Site Instruction

SI 24

PROJECT : Hampton Manor
PROJECT No : 1136.13
DATE : August 14, 2018

Title: Removal of Insulation behind Precast

section detail @ mid roof/precast panel 4
SCALE - 1/4\"/>

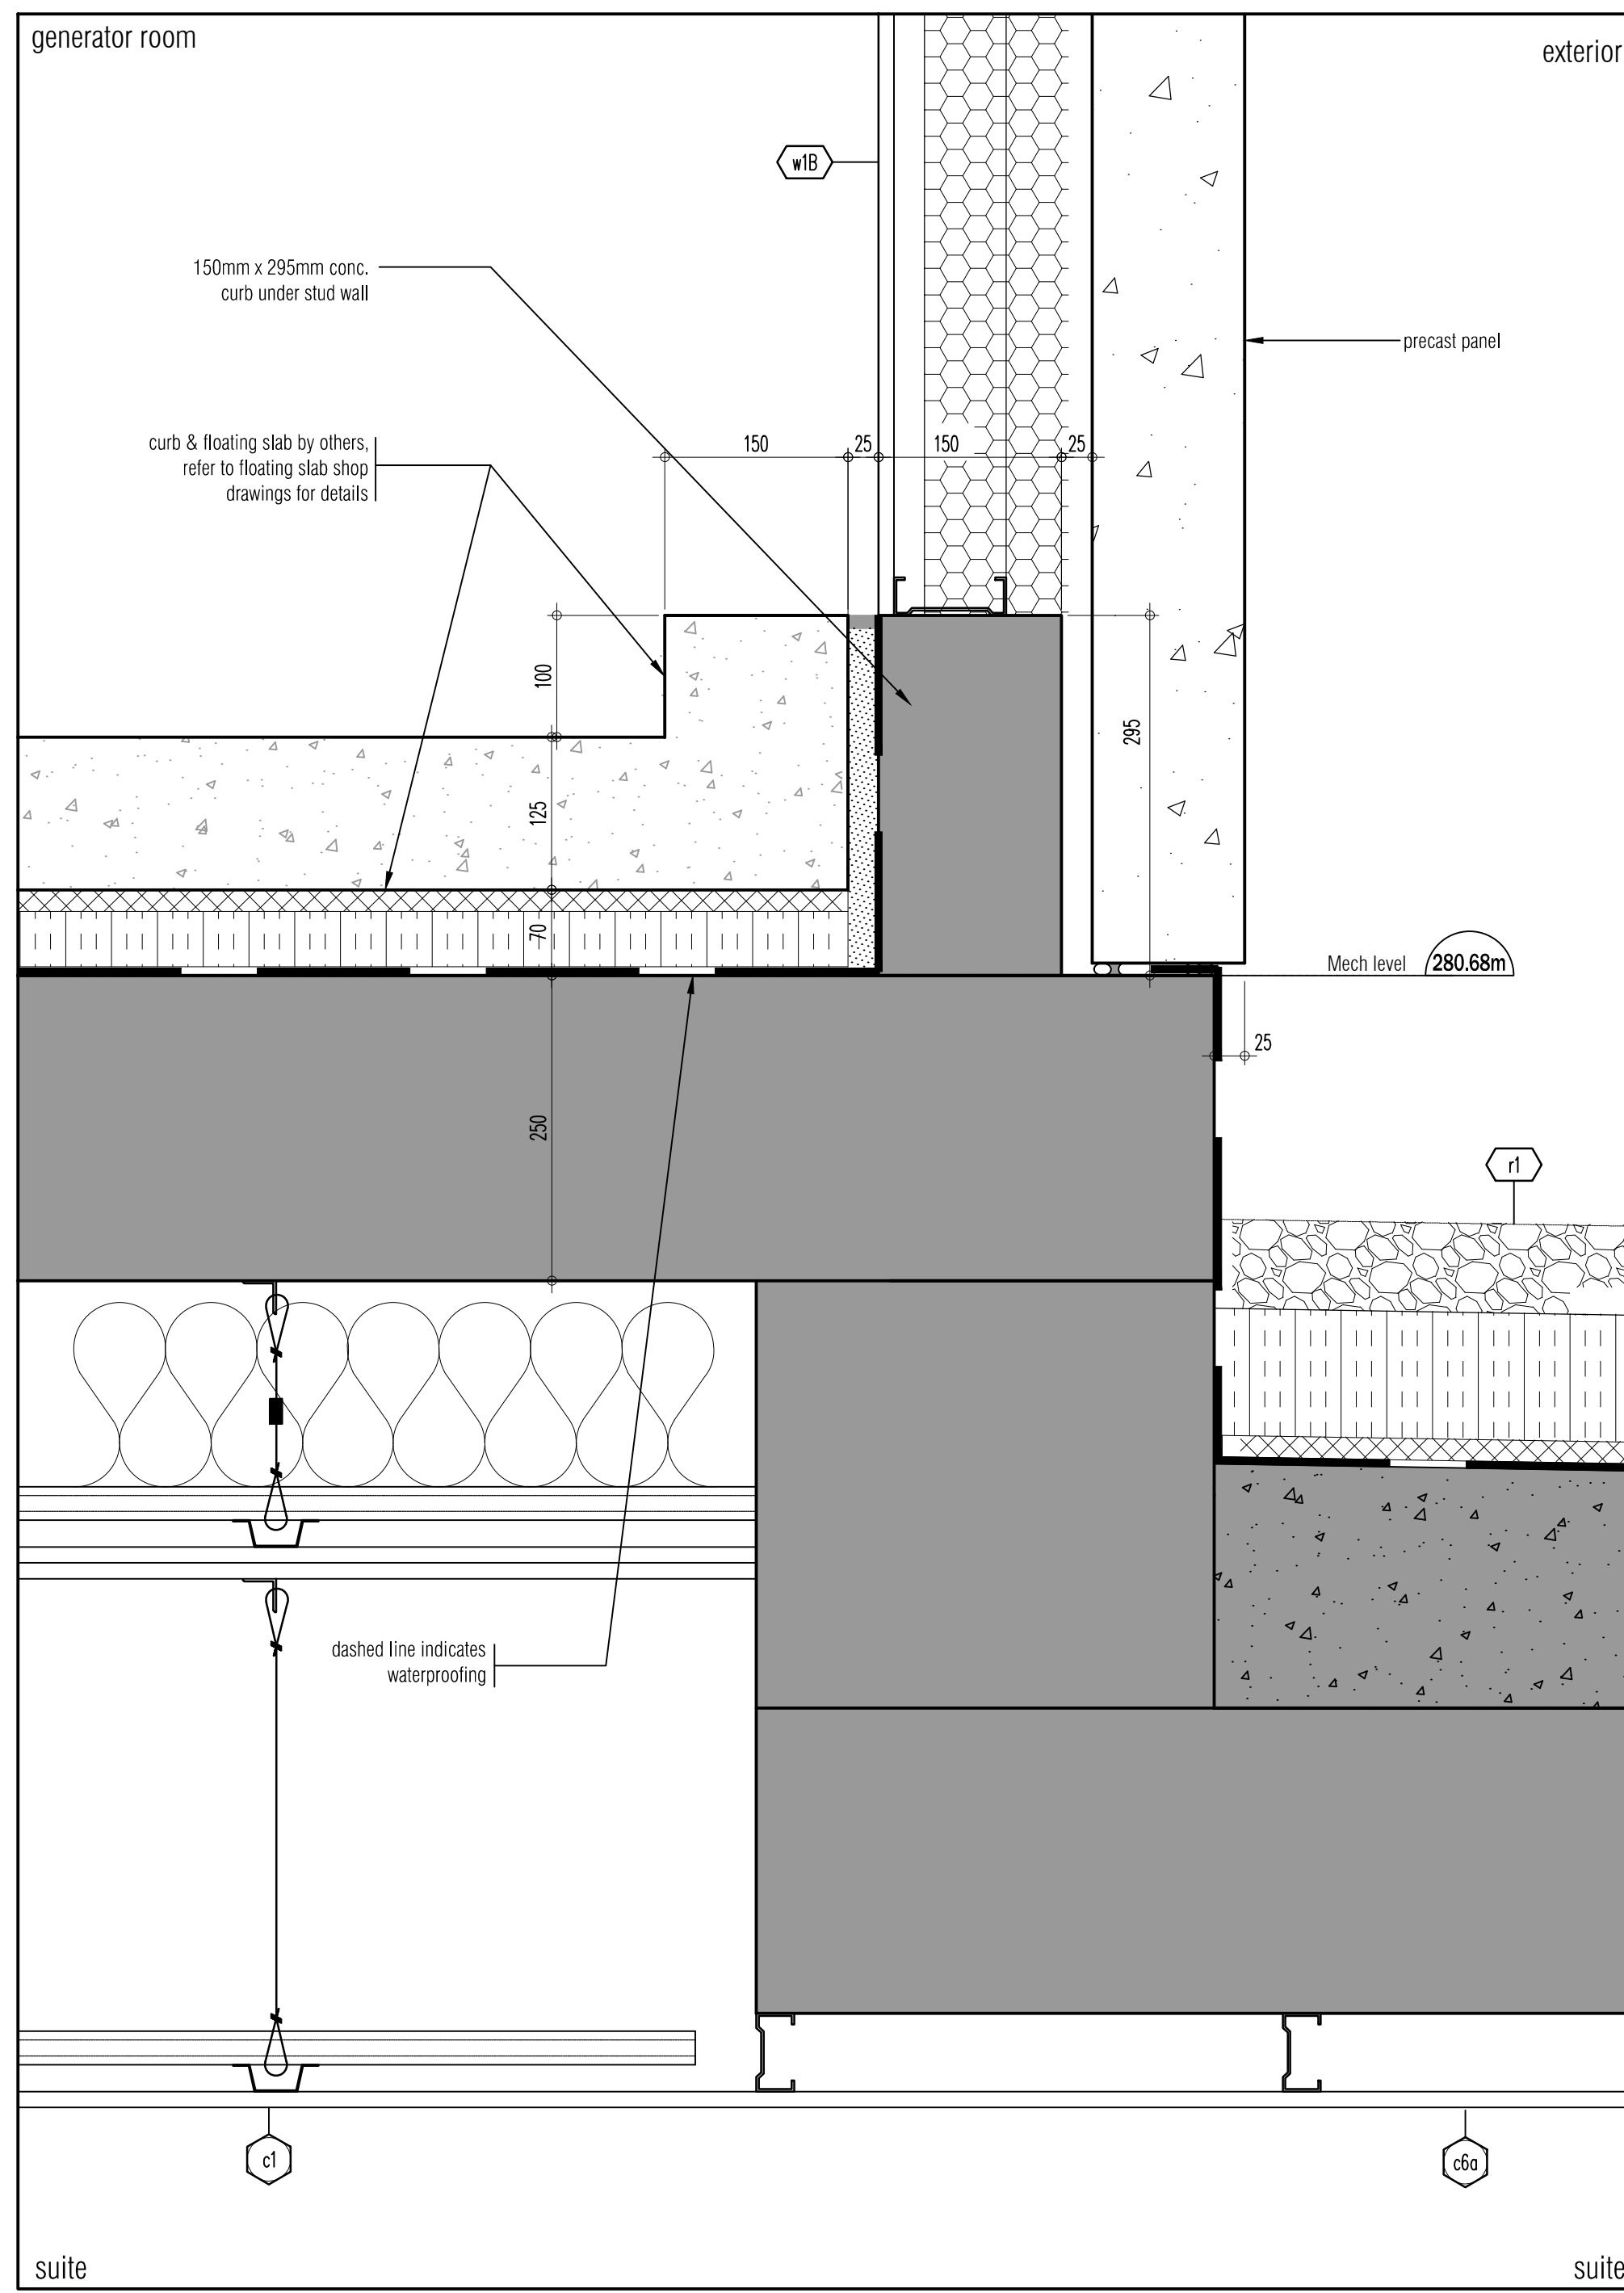
- Removal of insulation behind precast at terraces and roof.
